SERVICE BULLETIN

FORWARD AND CENTER THRUSTER CONTROL CABLES, CONDUIT CAP RELIEF AREA, INSPECTION

* Supersedes SB500N-020R1, SB600N-027R1 dated 24 November 1999.
Revision 2 corrects typographical errors Aircraft which have complied with SB500N-020R1, SB600N-027R1 meet the intent of this revision.

DATE: 24 APRIL 2000

Figure 1. Forward and Center Cable Relief Area Inspection (Sheet 1 of 2)

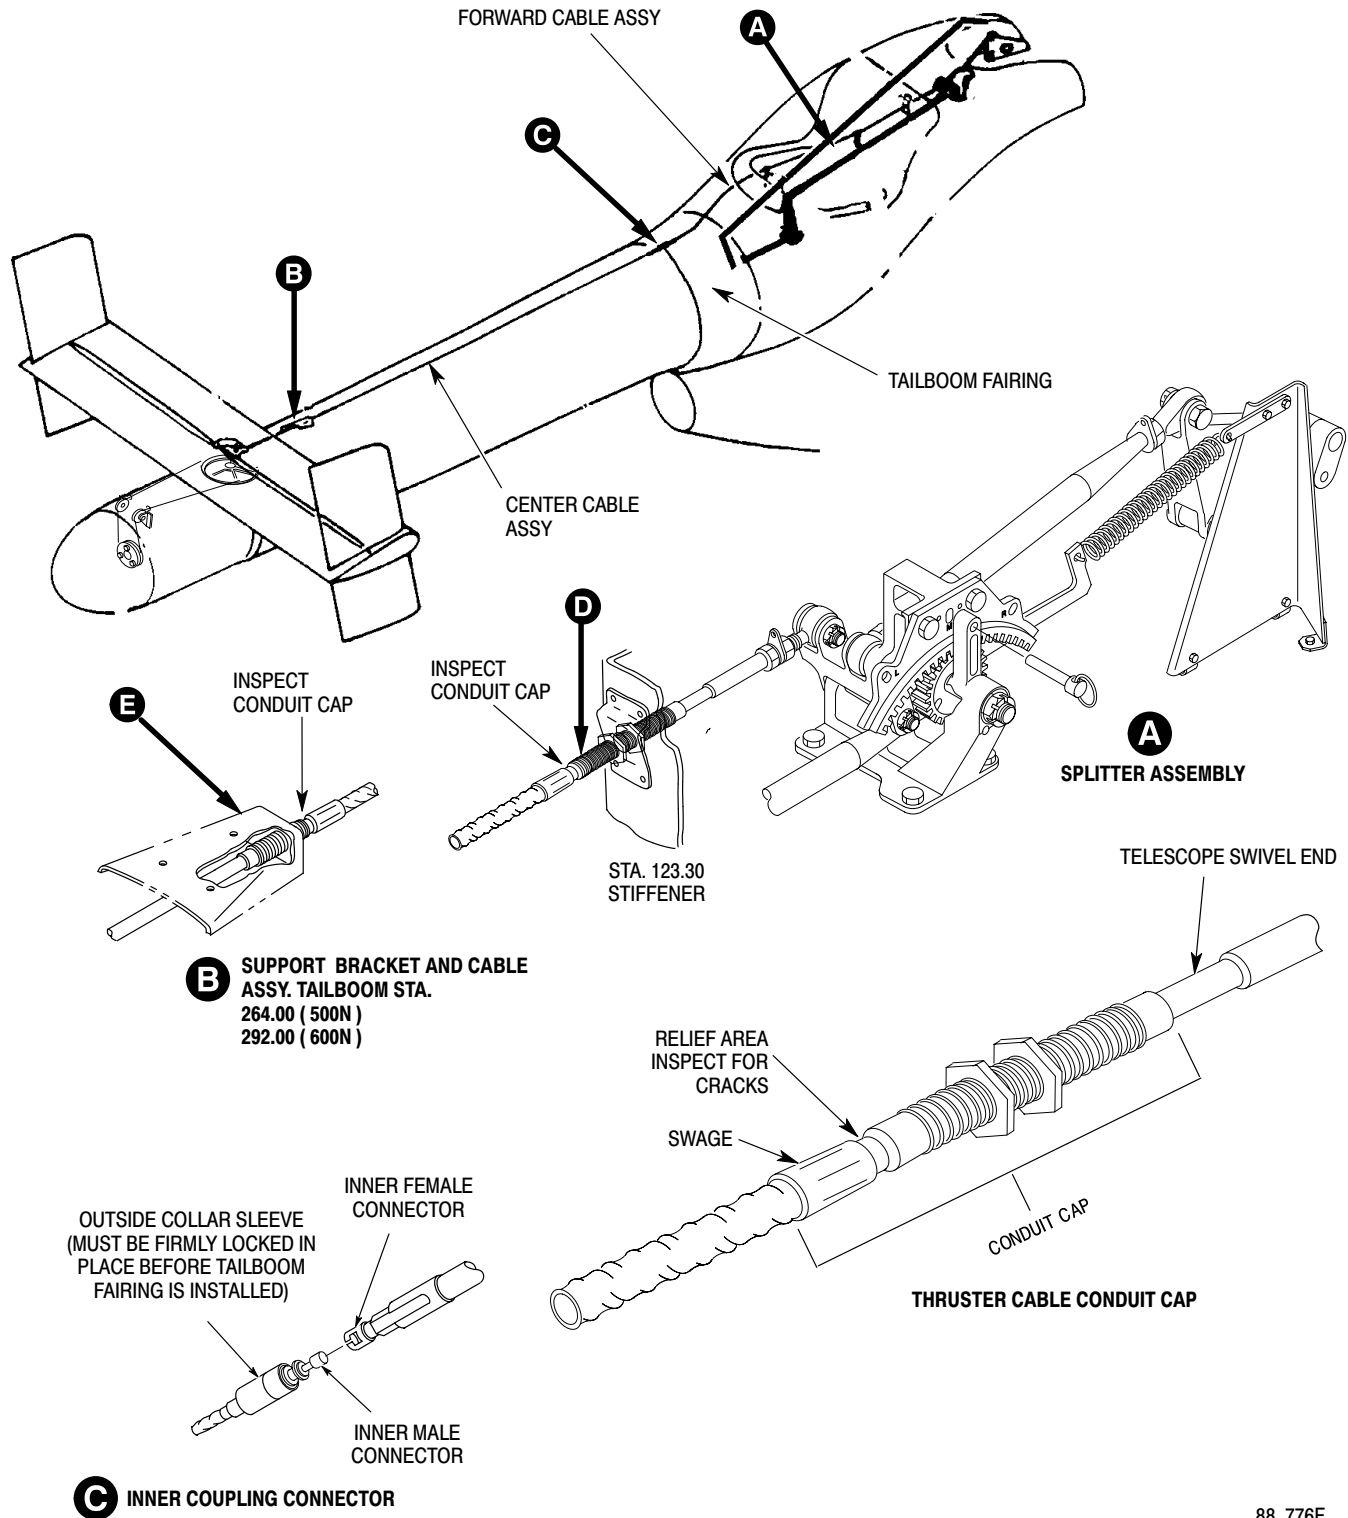
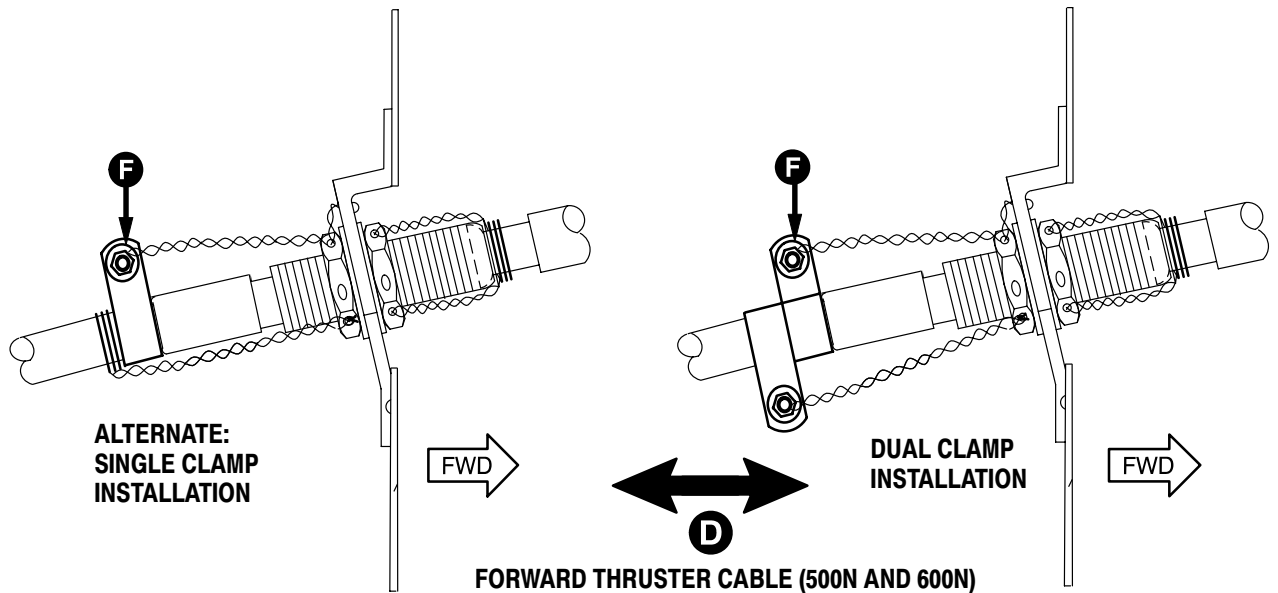
Operators have experienced stress corrosion cracks in the relieved area of the thruster control cable conduit cap. Cracks have been found between the swage and threads of both the forward cable at Sta. 123.30 (500N/600N) and the center thruster cable at Sta. 264.00 (500N) or Sta. 292.00 (600N).

- (1). 600N - Remove the engine air particle separator.
500N - Open the engine air particle separator bypass door.
- (2). Locate forward thruster cable on left side of plenum area.
- (3). Using a bright light, locate thruster control cable on left side of plenum area. Inspect relief area of cable conduit cap, just aft of mount bracket, between threads and swage for cracks or evidence of corrosion.

If the cable conduit cap has separated at the relief area, cable must be removed from service and a serviceable cable installed ***before further flight***.

- (4). If corrosion is found, clean corrosion area and inspect relieved area for crack.
- (5). Damage criteria requiring cable removal:
 - (a). Cable conduit cap which has separated at the relief area is not allowed.
 - (b). Any total crack length that exceeds more than 180 degrees around the conduit cap is not allowed.
- (6). If separation or an unacceptable crack is found, remove the cable and mark as scrap for return to MDHI. Replace with a serviceable cable which has been inspected per the requirements of this Bulletin.
- (7). Install two secondary safety clamps (AN742D6) as follows:
(Ref. Figure 1, View D and F)

NOTE: The two clamps are positioned 180° from each other. Do not allow the clamps to chaff against the airframe. The single safety clamp alternate installation can be installed if airframe structure interferes with the second clamp.

- (a). Install first clamp pointing up on the cable next to the swage.
 - (b). Install the second clamp pointing down on the cable next to the first clamp.
 - (c). Safety wire the bolt on the first clamp to the top of the jamnut that secures the cable to the airframe.
 - (d). Safety wire the bolt on the second clamp to the bottom of the jamnut that secures the cable to the bracket. If second clamp is not installed, alternate safety wire installation starts at the bottom of the jamnut, goes past the first clamp and is tightly wrapped around the cable a minimum of 3 times and a maximum of 5 times.
- (8). 600N - Install the engine air particle separator.
500N - Close the engine air particle separator bypass door.

- (1). Remove stationary and rotating thruster cones (Ref. CSP-HMI-2).
- (2). Using a bright light and a mirror, locate thruster control cable inside tailboom. Inspect conduit cap relief area, just forward of mount bracket, between threads and swage for evidence of corrosion.

- (3). If corrosion is found, clean corrosion area and inspect conduit cap relief area for cracks.
- (4). Damage criteria requiring cable removal:
 - (a). Cable conduit cap which has separated at the relief area is not allowed.
 - (b). Any total crack length that exceeds more than 180 degrees around the conduit cap is not allowed.

- (5). If separation or an unacceptable crack is found, remove the cable and mark as scrap for return to MDHI. Replace with a serviceable cable which has been inspected per the requirements of this Bulletin.
- (6). Install two clamps (AN742D6) as follows:
(Ref. Figure 1, View E and F)

NOTE: The two clamps are positioned inside the tailboom approximately 180° from each other. Do not allow the clamps to chaff against the tailboom.

- (a). Install the first clamp on the cable next to the swage pointing up along the top portion of the tailboom.
- (b). Install the second clamp on the cable next to the first clamp pointing down along the bottom portion of the tailboom approximately 180° from the first clamp.
- (c). Safety wire the bolt on the first clamp to the top of the jamnut that secures the cable to the airframe.
- (d). Safety wire the bolt on the second clamp to the bottom of the jamnut that secures the cable to the airframe.

Figure 1. Forward and Center Cable Relief Area Inspection (Sheet 2 of 2)

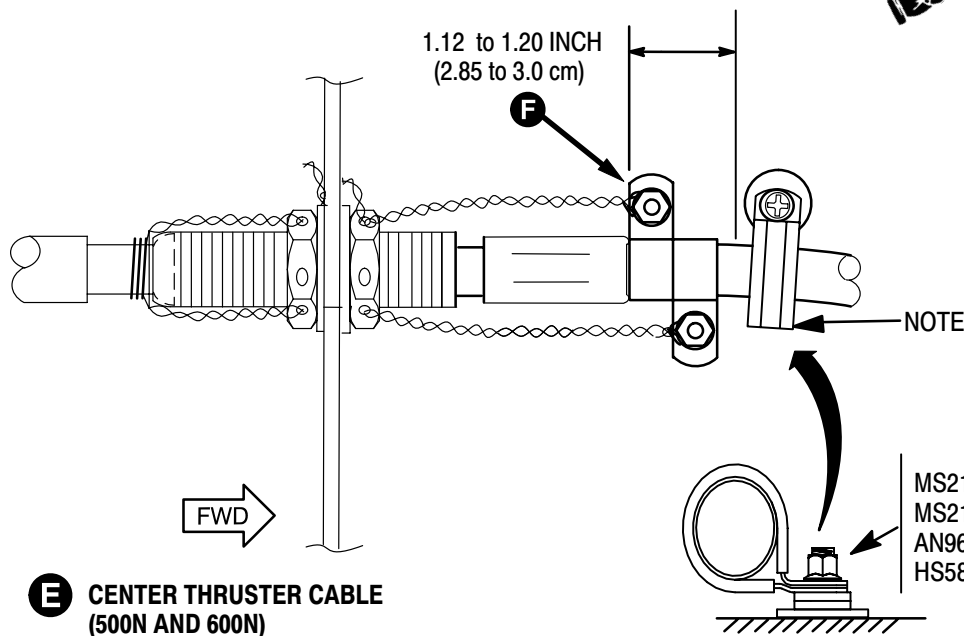
- (7). Install one Click Bond and clamp (MS21919WD6) as follows:
(Ref. Figure 1, View G)

During scuff sand operation of 600N tailboom surface , DO NOT sand into graphite material of tailboom surface.

NOTE: If surface is primed, then it is only necessary to wipe with isopropyl alcohol and air dry for 15 minutes (no sanding required).

- (a). If necessary, scuff sand a 2 inch (5 cm) diameter area approximately one inch from the end of the conduit cap metal swage on the unprimed surface of the tailboom to remove loose resin or surface gloss.
 - (b). Wipe with isopropyl alcohol and air dry for 15 minutes.
 - (c). Mix Click Bond per manufacturers instructions.
 - (d). Install adhesive per manufacturers instructions.
 - (e). Insert the cable into clamp (MS21919WD6) and position clamp approximately 1.12 to 1.20 inches (2.85 to 3.0 cm) from the end of metal swage.
 - (f). Install two (AN960KD10) washers (HS 5806CR-3CR8) on the stud, one (MS21919WDG6) clamp, and nut (MS21042L3)).
- (8). Reinstall stationary and rotating thruster cones (Ref. CSP-HMI-2).
 - (9). Rig the rotating thruster cone (Ref. CSP-HMI-2).

G CLAMP INSTALLATION TO TAILBOOM WITH CLICK BOND
(600N HELICOPTERS ONLY)

NOTE: CLICK BOND INSTALLATION (600N ONLY)
